Peoria Park District
Bradley Park Equipment Service Center
1314 N. Park Road
Peoria, IL 61604
Telephone: (309) 686-3386

ADDENDUM NO. ONE

PROJECT TITLE: Bridge Erosion Protection
Robinson Park - South

ISSUANCE DATE: April 27, 2016

3 FOUNDATION & BEARING DETAIL
 Scale: 1/2"=1'-0"

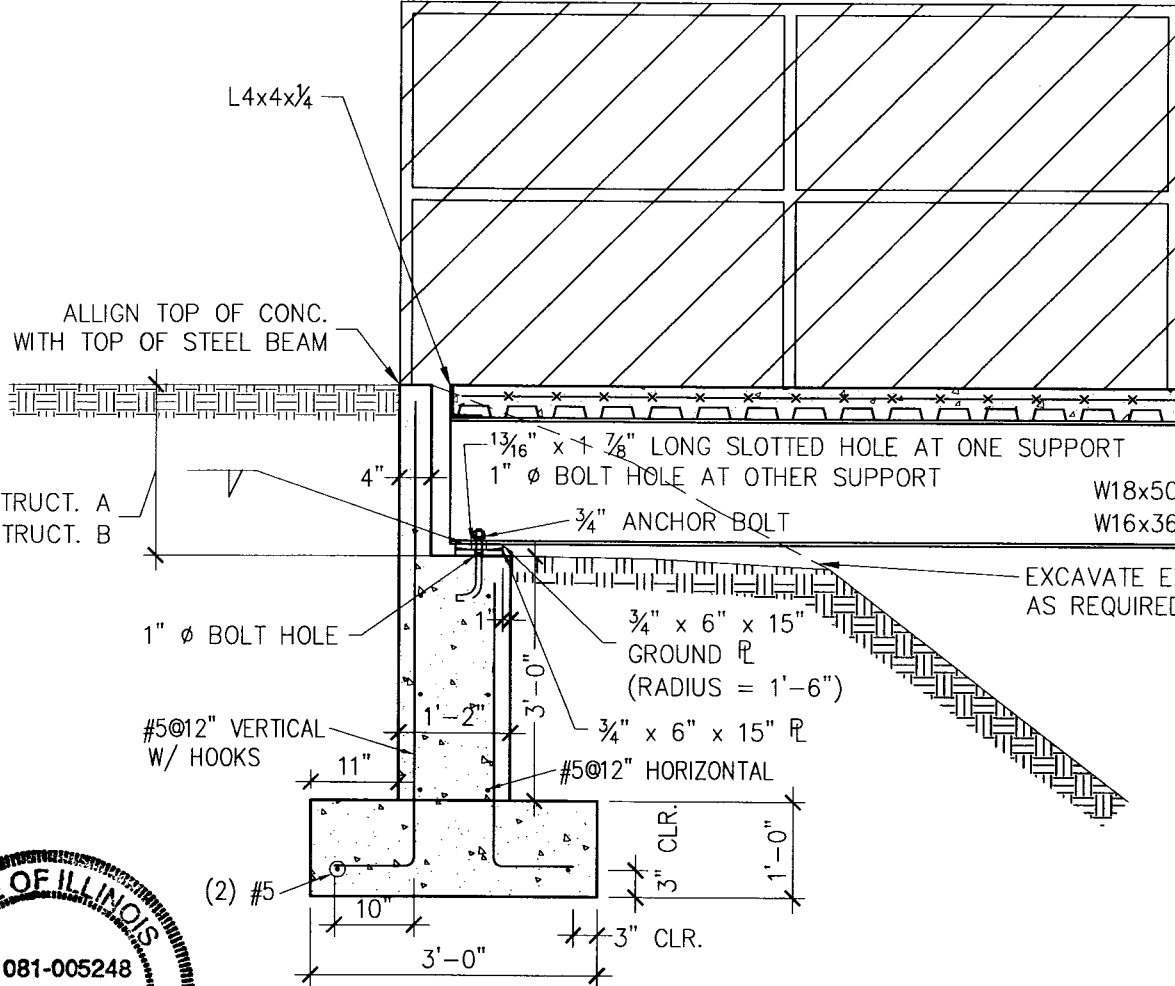
At the Pre-bid meeting, the Owner's Representative stated that the bridge foundation incorporated piles. This is incorrect. The attached plan sheet shows the bridge foundations. Excavation and placement of new gabion baskets shall be limited so as to not undermine the existing bridge foundation.
